ADDENDUM NO. 1
to
CONTRACT DOCUMENTS

for
ADDITIONS AND RENOVATIONS
to the
PRINCETON MIDDLE SCHOOL
located at 217 Walnut Lane, Princeton, NJ 08540

Issued: January 15, 2026

FVHD PROJECT NO. 5516B

Drawing Number
C-8.2

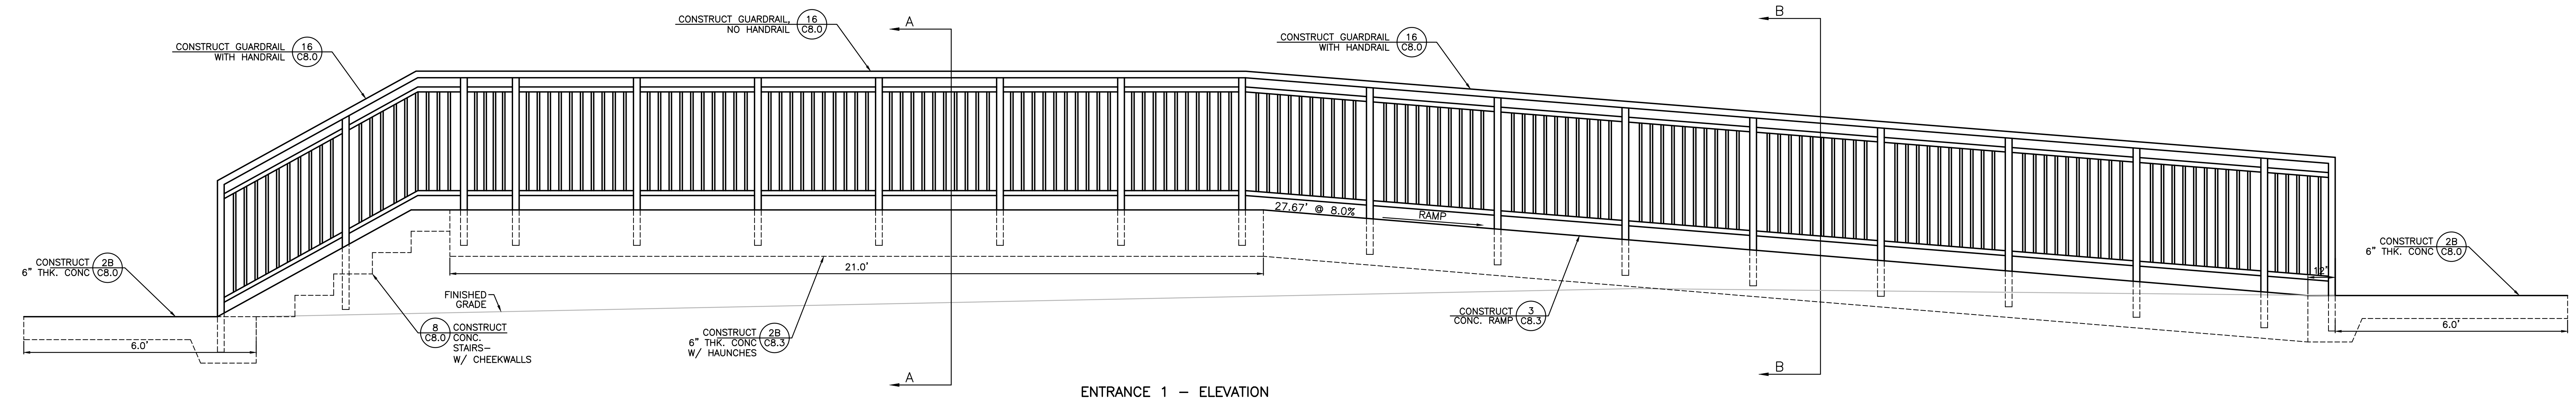
6. Question: Please provide Bike Rack Manufacturer & Model # & provide details for footing if applicable.

Response: See Detail 3 (“Permanent Steel Bike Rack”) on revised drawing C8.2, attached to this Addendum.

Drawing Number
A104

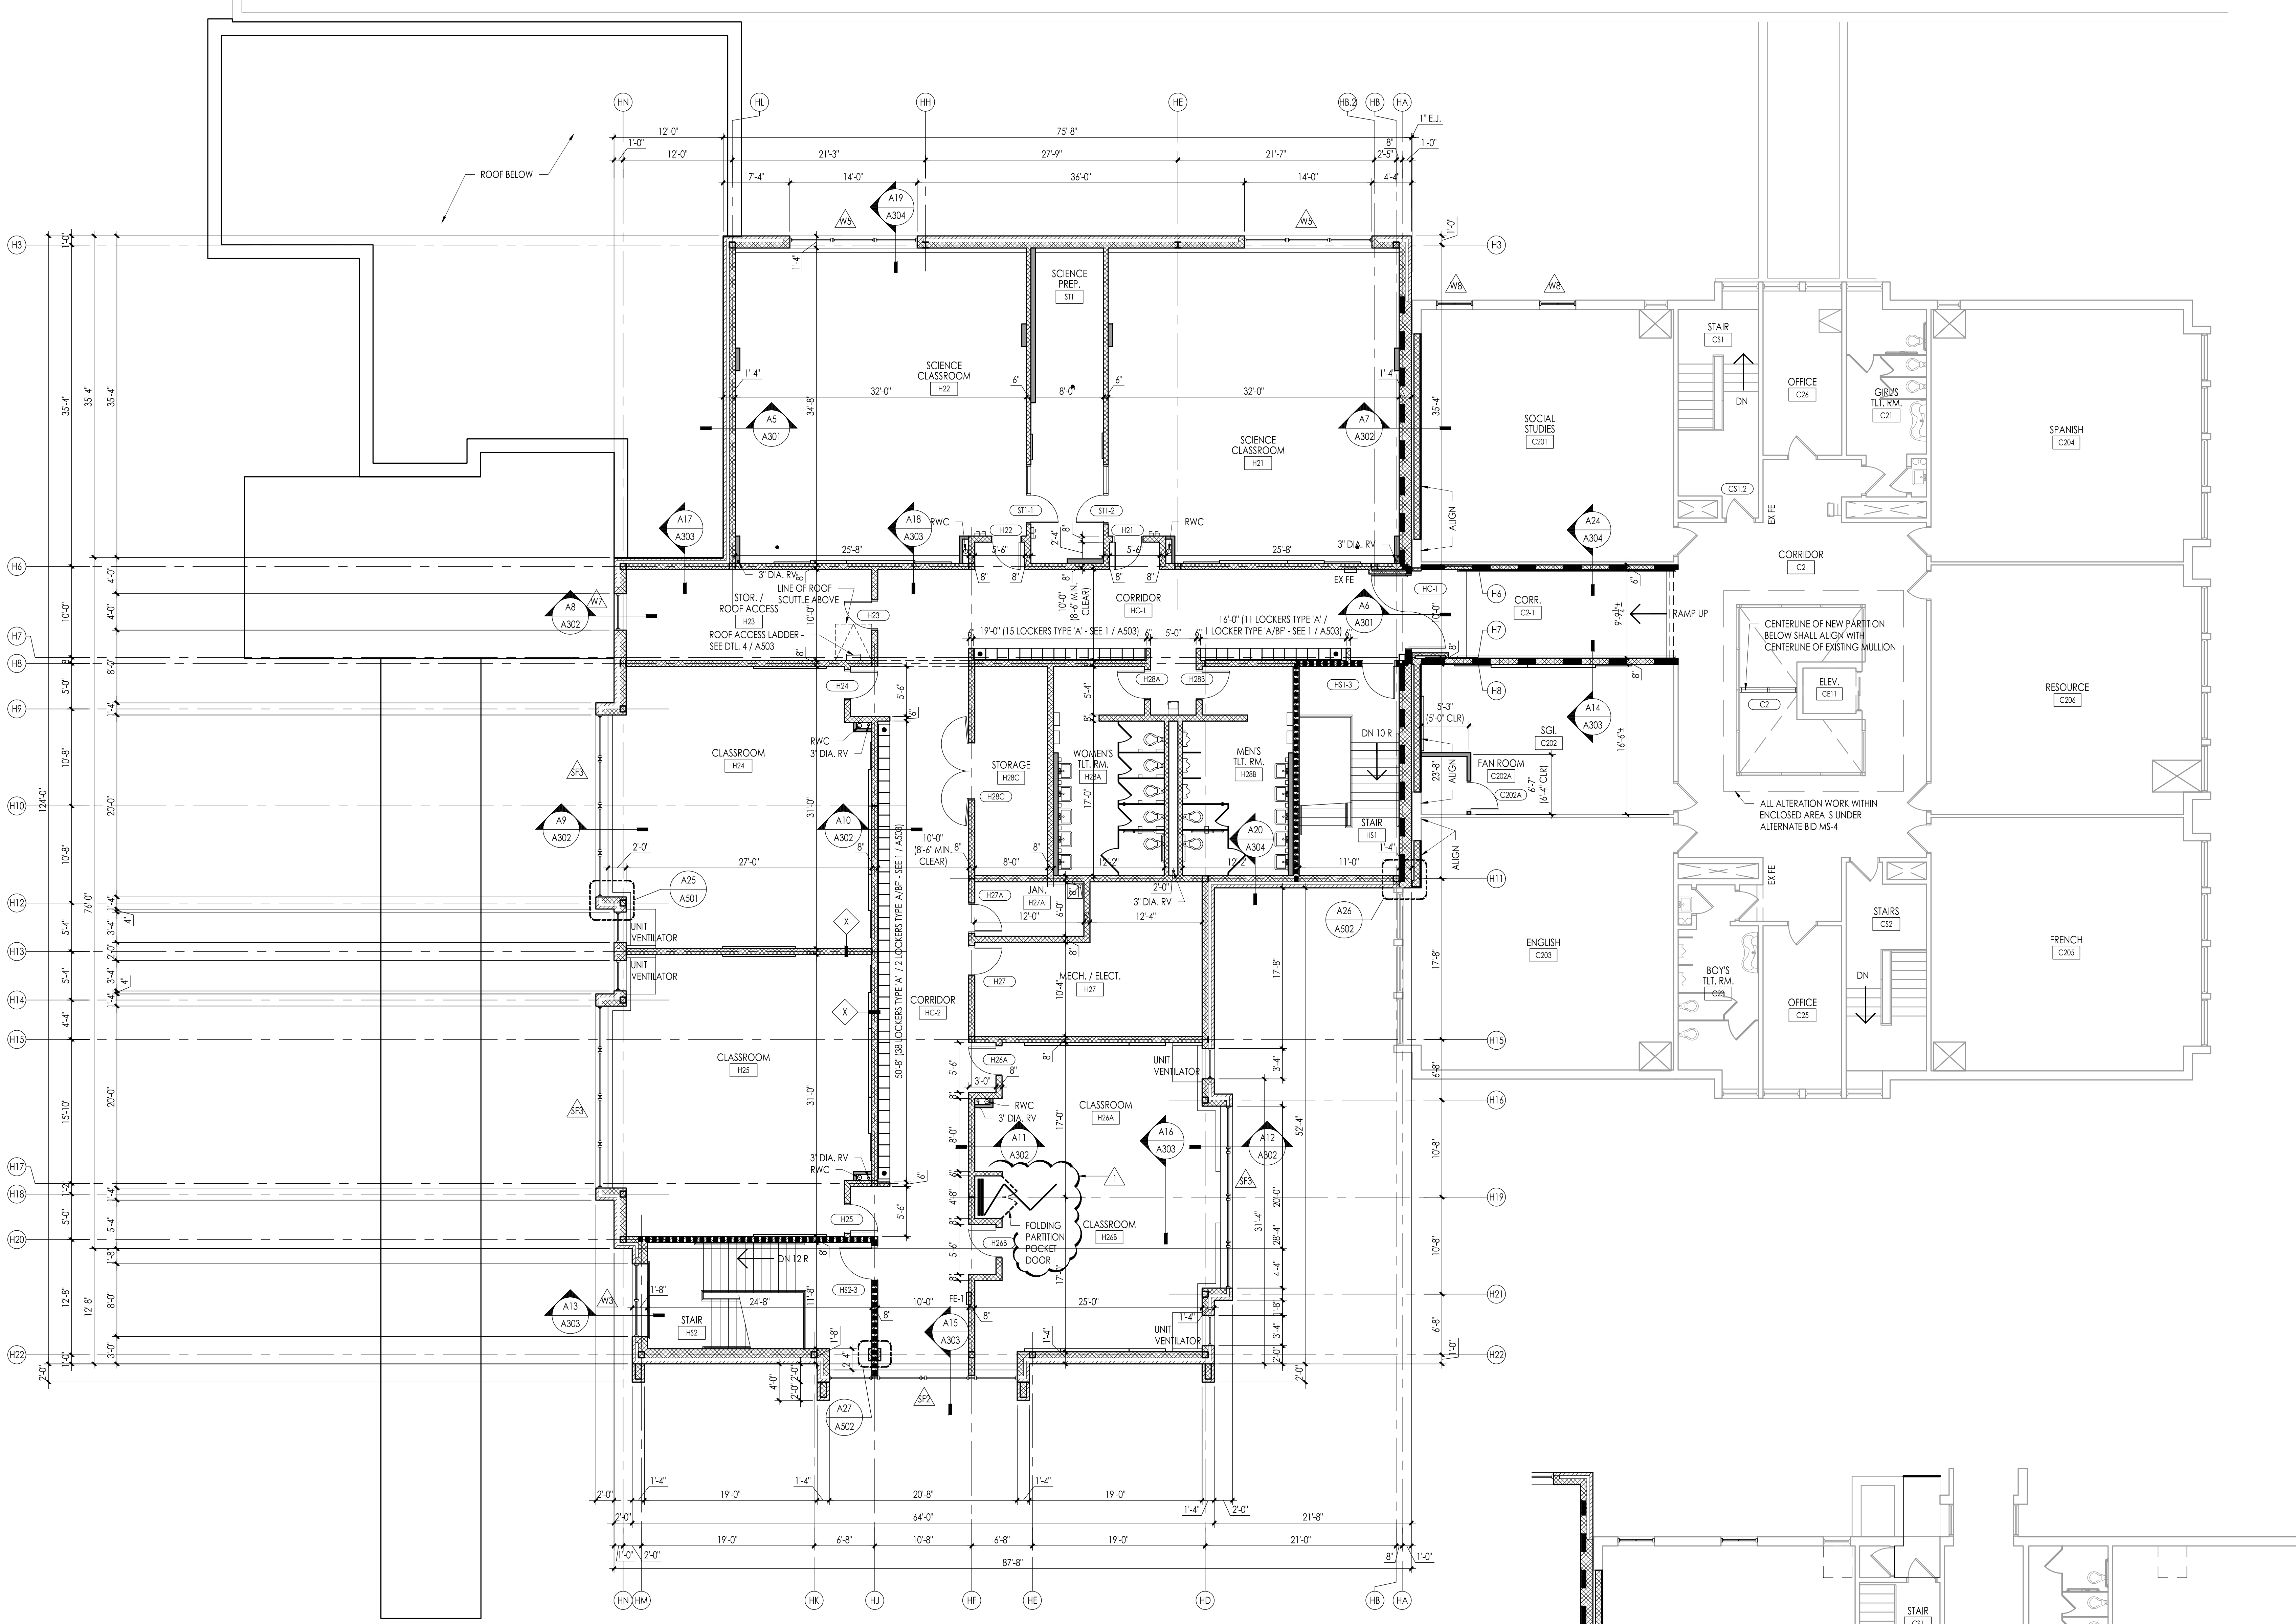
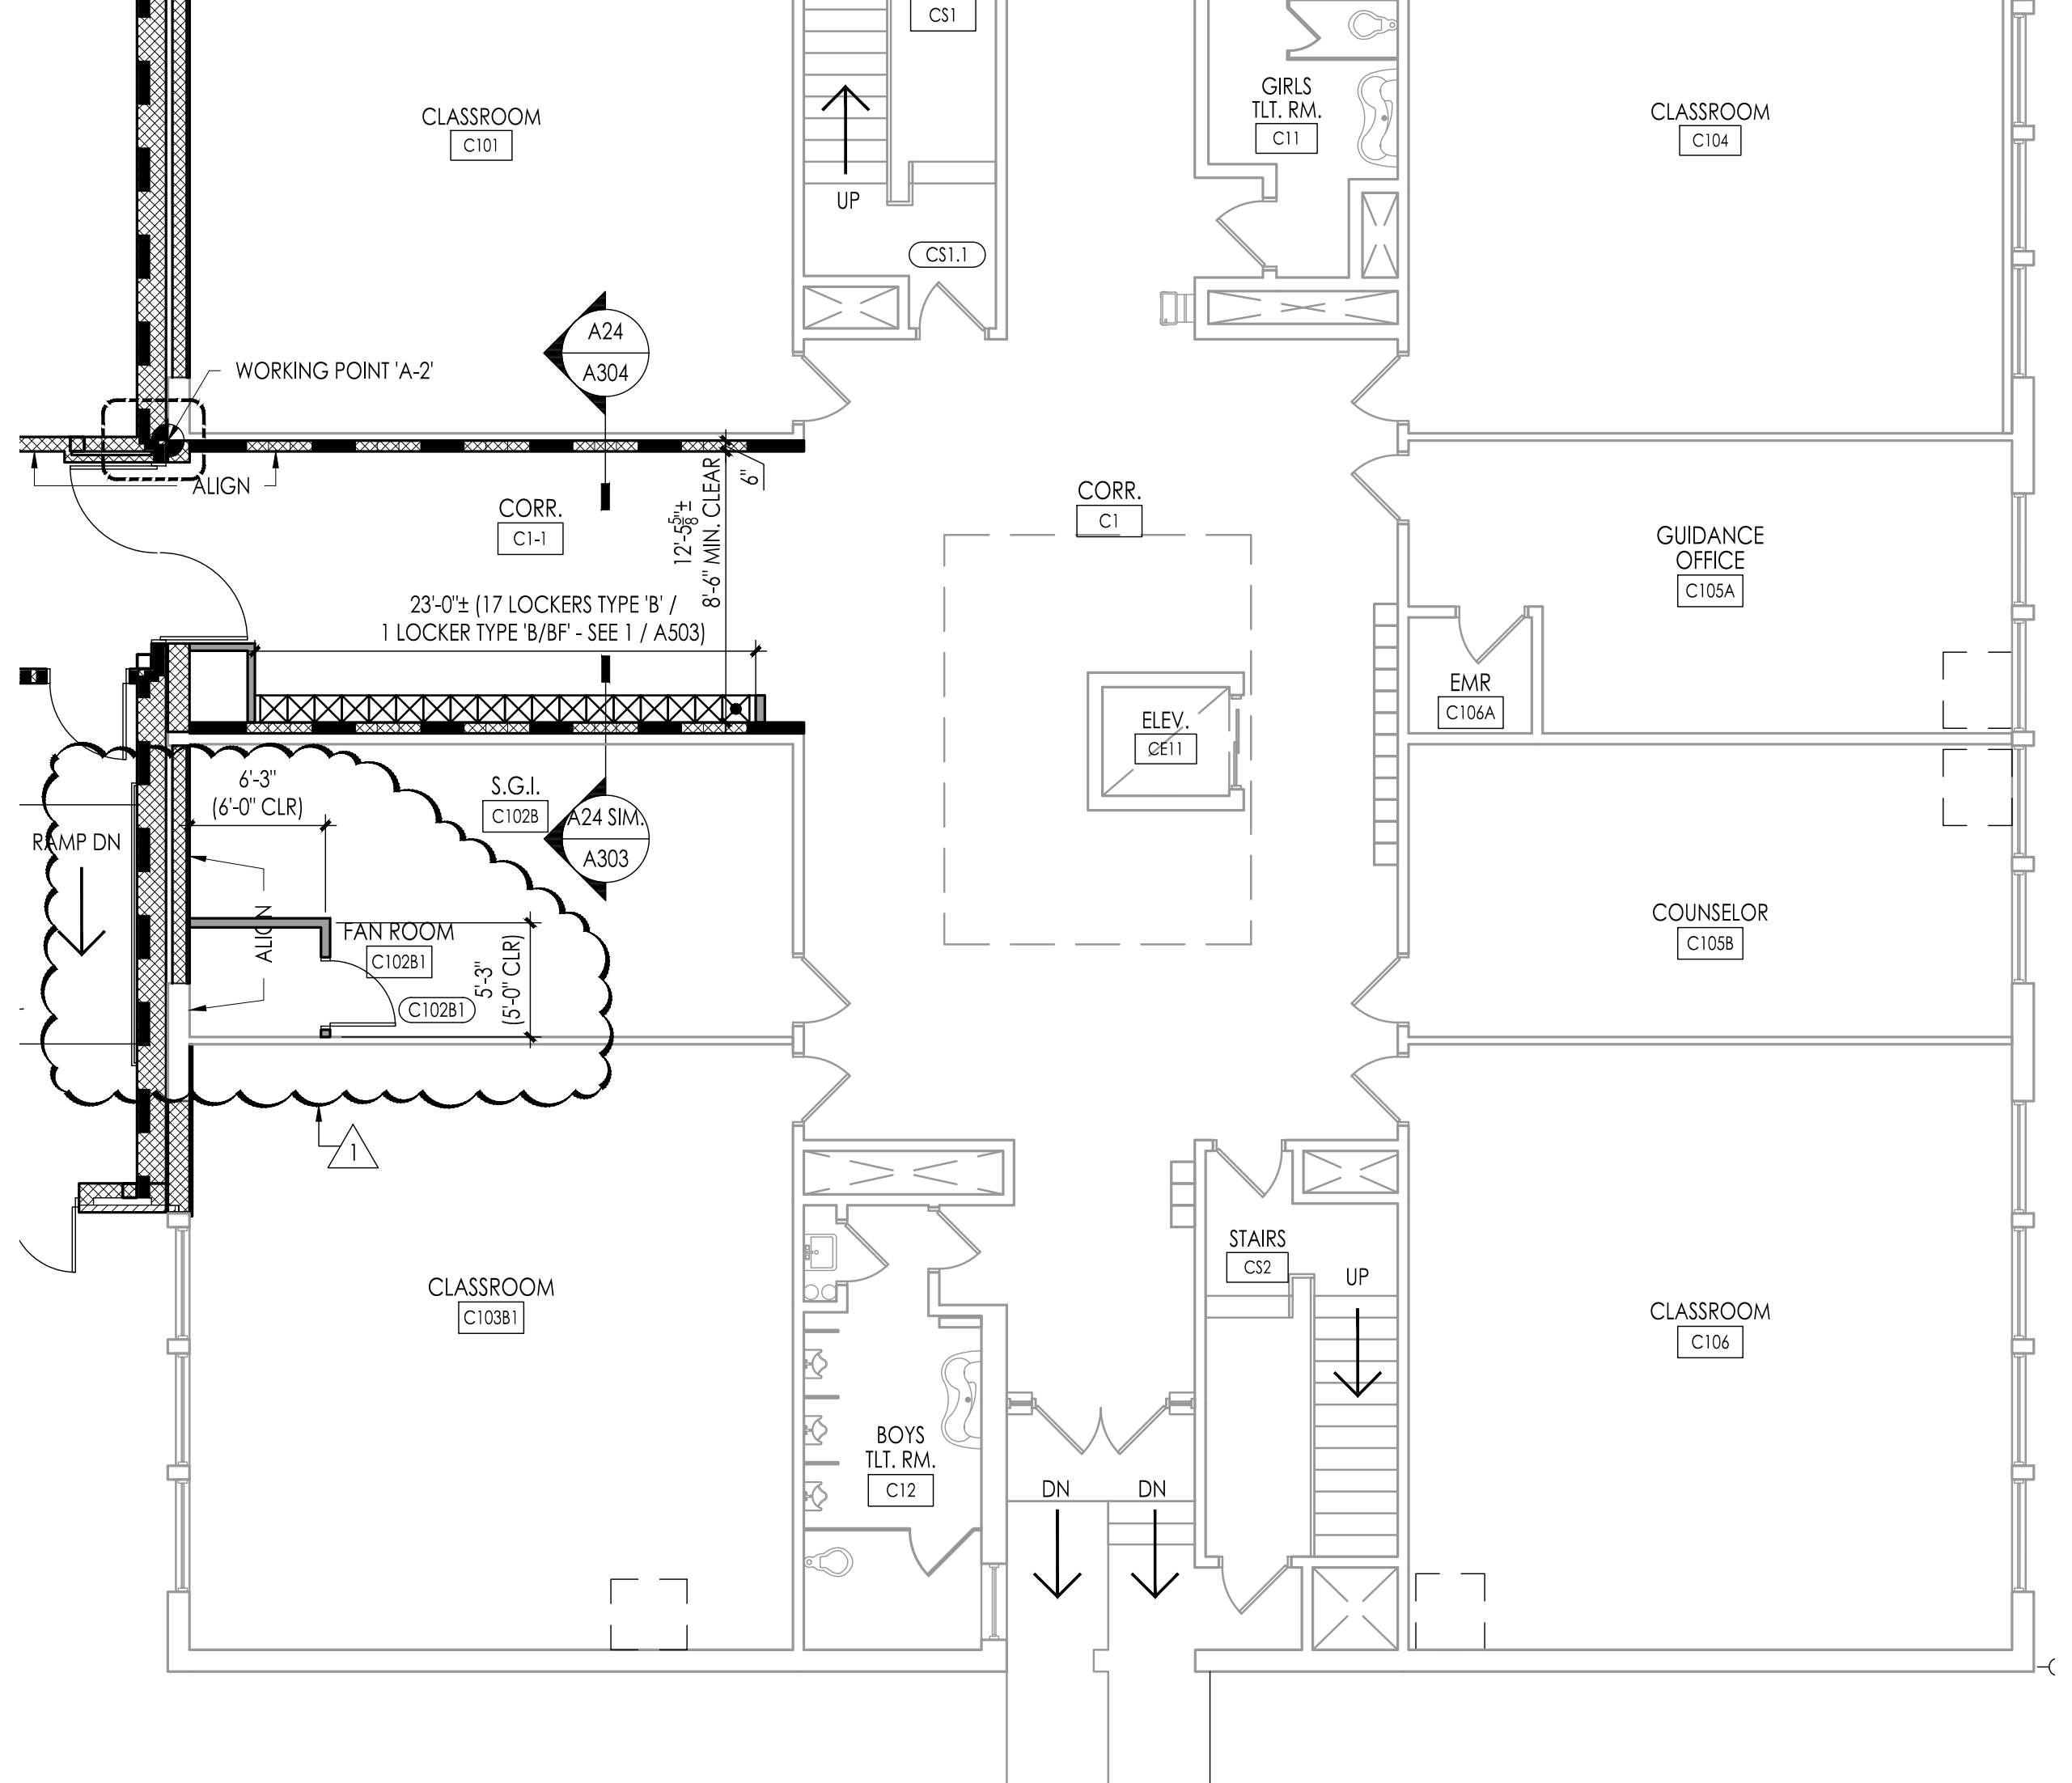
13. Question: "Pocket doors" – Specifications include pocket doors, pocket doors are NOT shown on drawings. Please confirm if they are to be included for all units.

Response: Pocket doors are required at the recesses where the folding partitions are stacked when not deployed. See revised A103, A104 and A105, attached to this Addendum.
